PLANNING AND ZONING AND COUNTY COUNCIL INFORMATION SHEET
Planning Commission Public Hearing Date May 27th, 2021

Application: The Crossings (FKA The Crossing at Trap Pond) (2020-10)

Proposed Use: 39 Single Family Lots as an AR-1 Cluster Subdivision

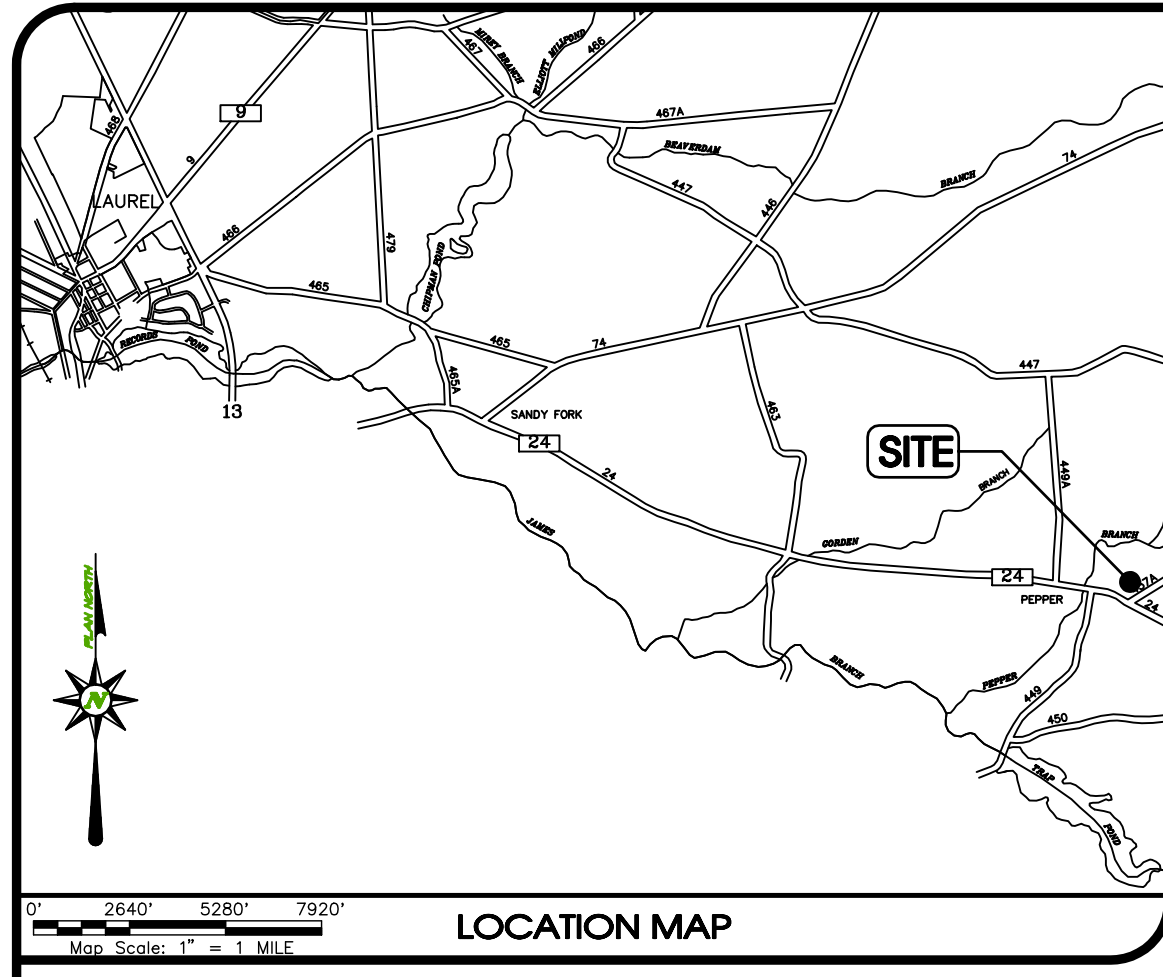
DCM 3.3 outlines the requirements for minor residential subdivisions, that the property owner must coordinate access with DeIDOT. In our opinion, to preserve capacity and maintain safety on Adams Road, the four proposed lots should take access from an internal subdivision street, which according to the major concept plan would only require 35' of private right-of-way, and could run along the backs of the four minor lots.

I've included Sussex County on this email so that they can understand DeIDOT's opinion and recommendation. If the County does not agree with DeIDOT and will allow the minor subdivision separate from the major subdivision, please understand that there will be no waivers or deviations allowed by DeIDOT for the improvements required under the major subdivision, including but not limited to, turn lane lengths, slopes, lane widths.
